ADDENDUM NO. 1

June 15, 2011

Duluth International Airport
New Passenger Terminal
Voluntary Air Low Emissions (VALE)
Duluth, MN 55811

Addendum No. 1

SHEET NUMBER
A715
VALE PROGRAM BID PACKAGE

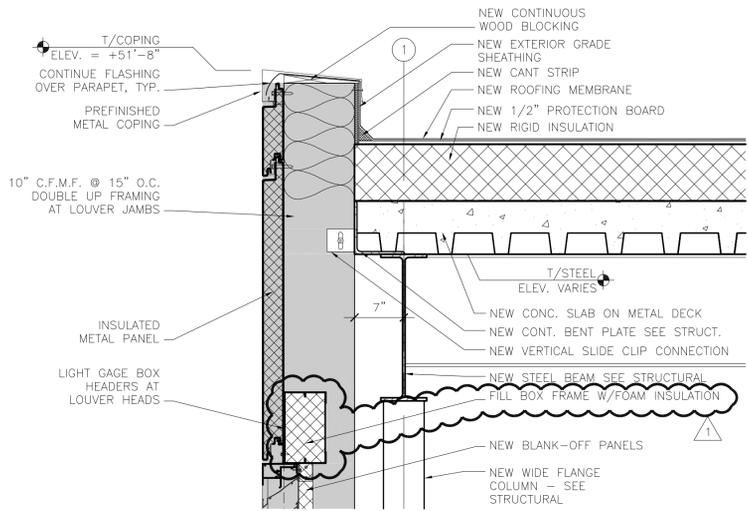
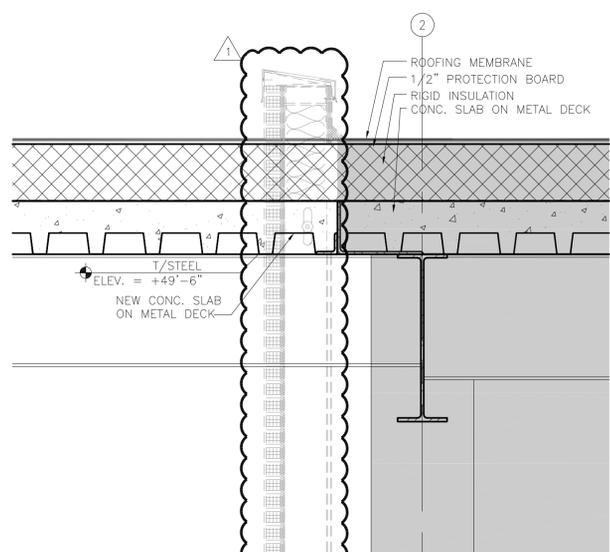
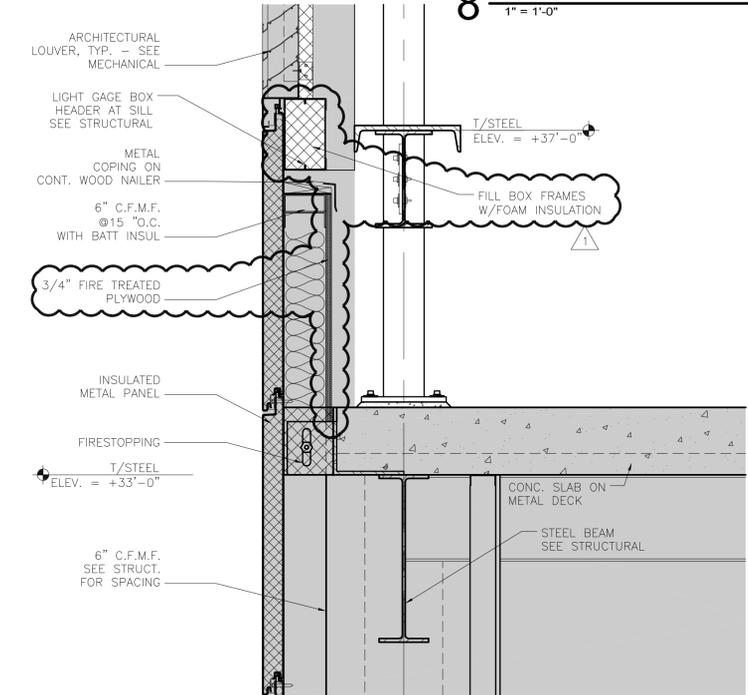
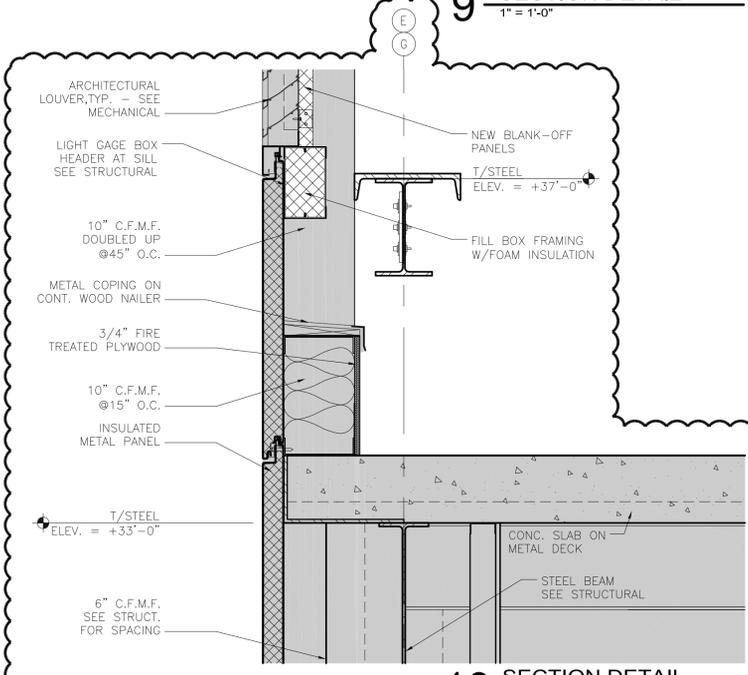
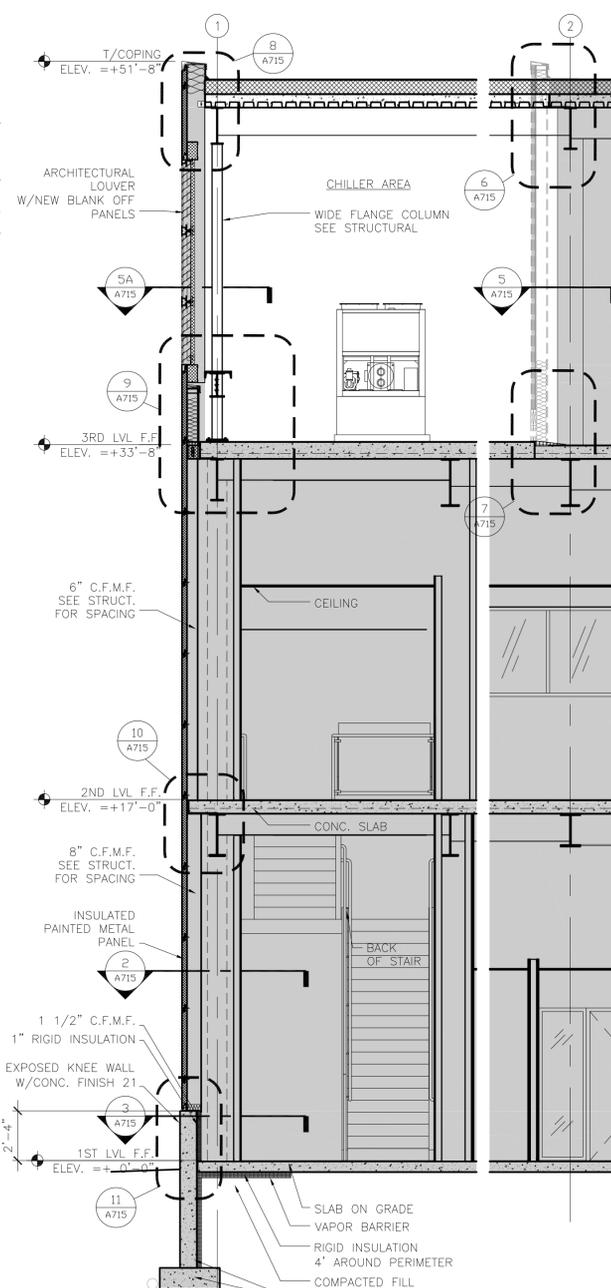
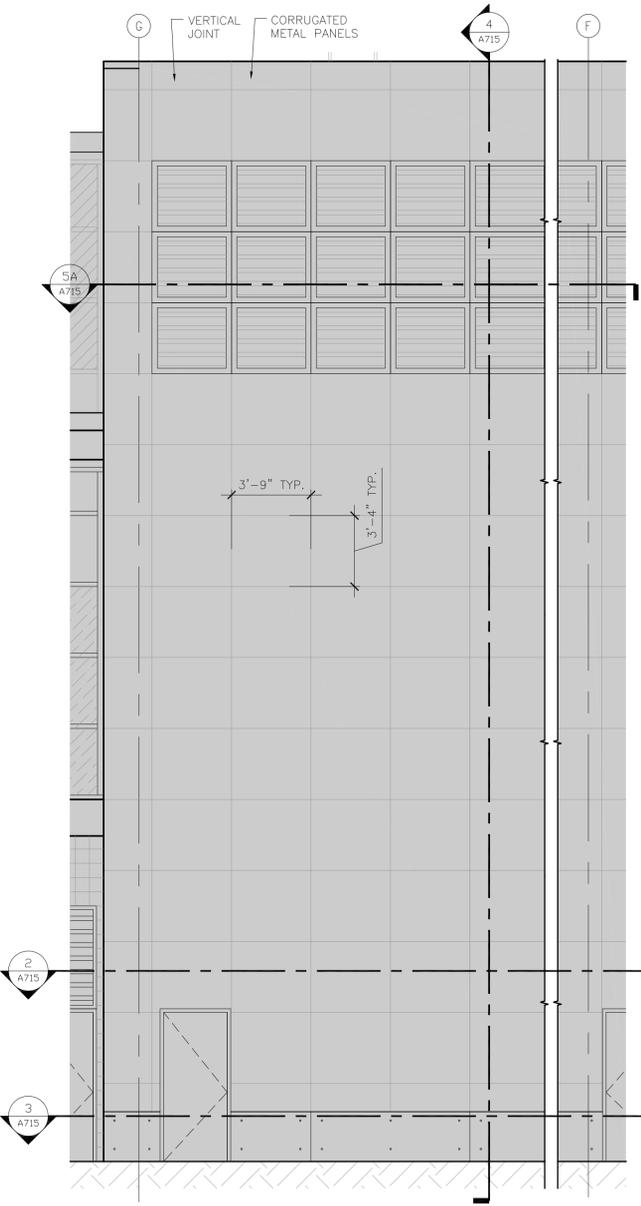
Sheet A715 – Exterior Systems Core Wall: Revised Targeting; Added Note and Details.

SHEET NUMBER
M-101

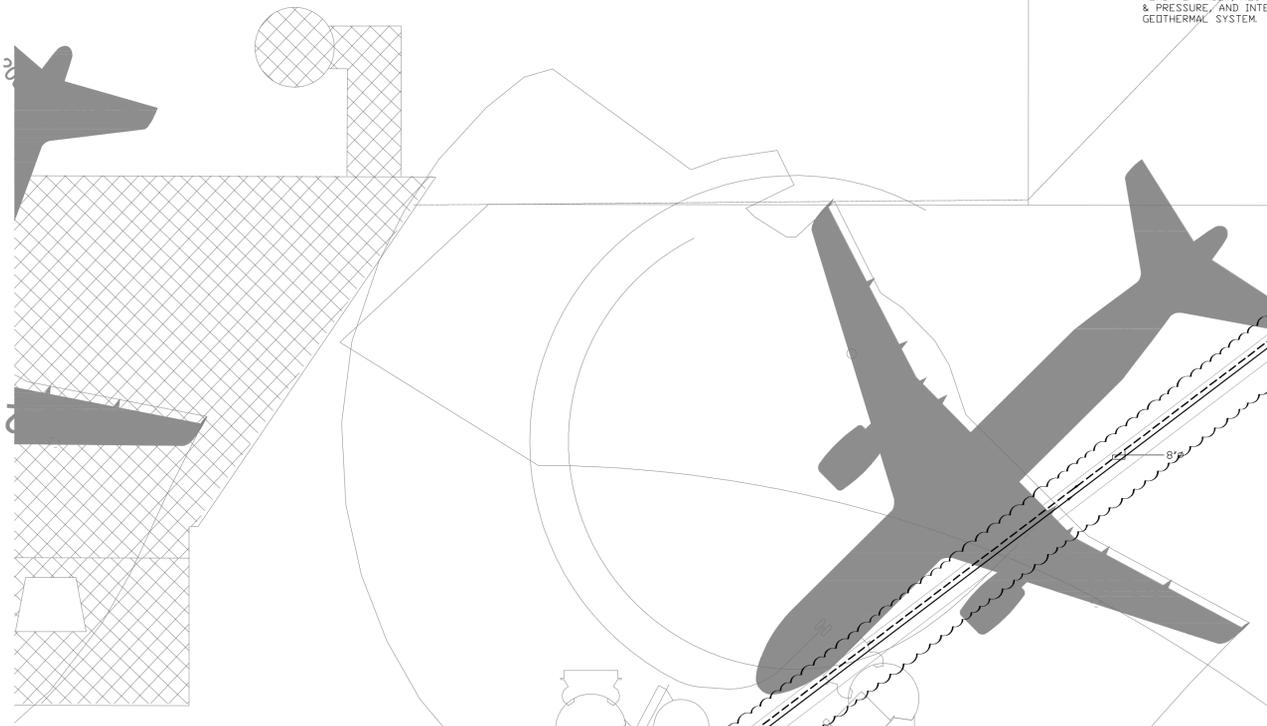
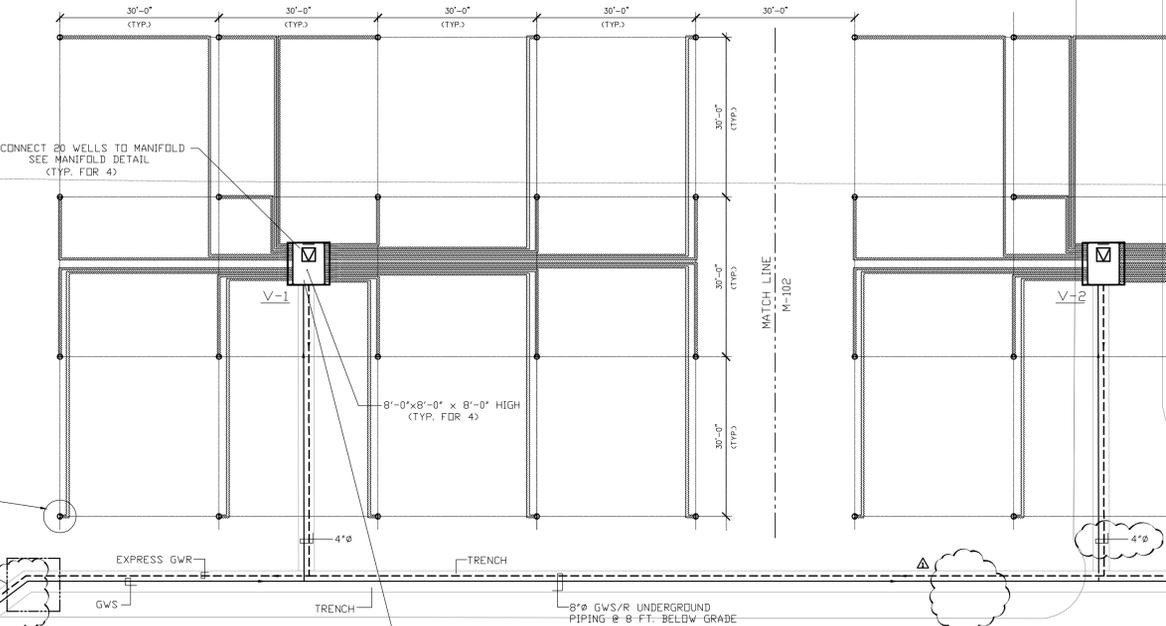
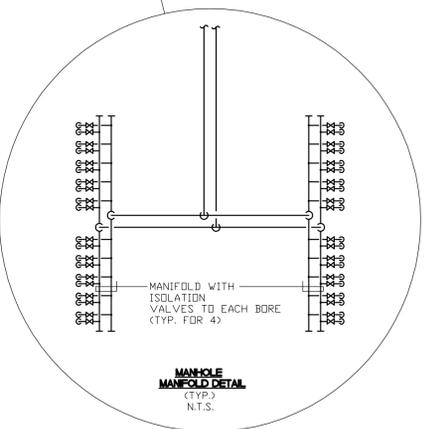
Sheet M-101 – Geothermal Site Mechanical Partial Plan: Revised GWS & GWR Piping Sizes and Routing.

SHEET TITLE
GEOTHERMAL SITE MECHANICAL PARTIAL PLAN

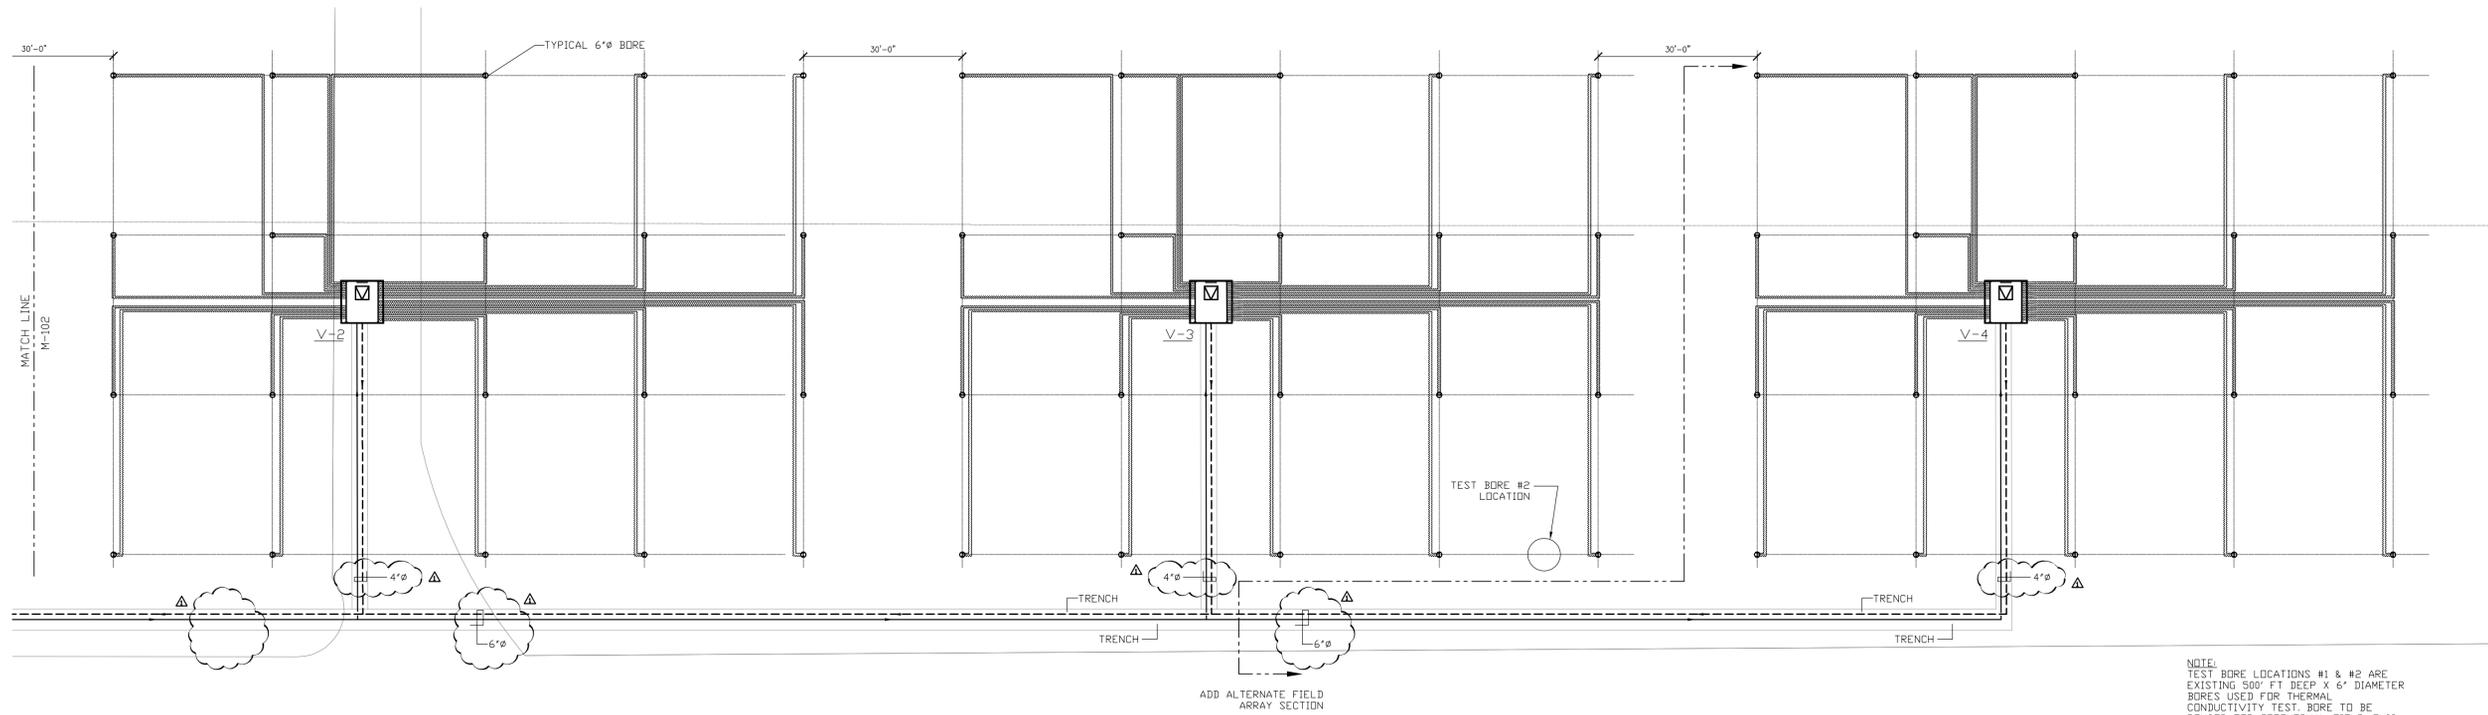
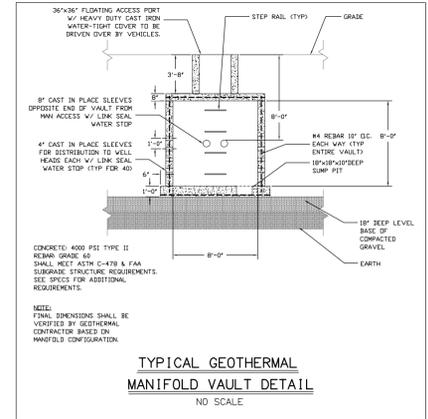
Sheet M-101 – Geothermal Site Mechanical Partial Plan: Revised GWS & GWR Piping Sizes.
